California Regional Water Quality Control Board San Francisco Bay Region

Tentative Order No. R2-2017-00XX

Amendment of Order No. R2-2014-0010
(NPDES No. CA0030210)
for Lehigh Southwest Cement Company, and
Hanson Permanente Cement, Inc.,
Permanente Plant
Cupertino, Santa Clara County

ATTACHMENT 2 – FACILITY MAP

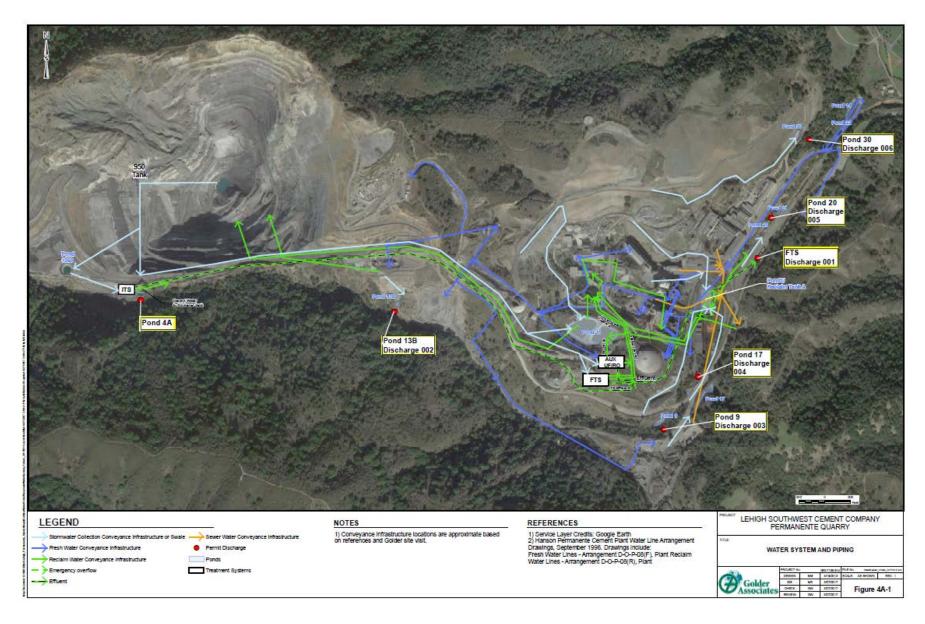
- **1.** Replace Permit Attachment B, page B-2, with Attachment 2 of this Order ("Facility Map").
- **2.** Replace Permit Attachment C, page C-3, with Attachment 3 of this Order ("Revised Final Line Drawing of Flows; Final Treatment Flow Configuration").
- **3.** Revise Permit Table 2 as follows:

1. Replace Permit Attachment B, page B-2, with Attachment 2 of this Order ("Final Facility Map").

Permit provision III.A prohibits discharges other than those shown in the facility map in Attachment B, page B-2. The map shows Discharge Point Nos. 001 through 006 and the Facility's water and wastewater conveyance system. Attachment 2 of this Order updates the discharge points and process flow diagram to match the Discharger's design. The new location for Discharge Point No. 001 will allow discharge by gravity at a location nearer to the final treatment system, which will require less pumping and allow for a simpler process flow configuration.
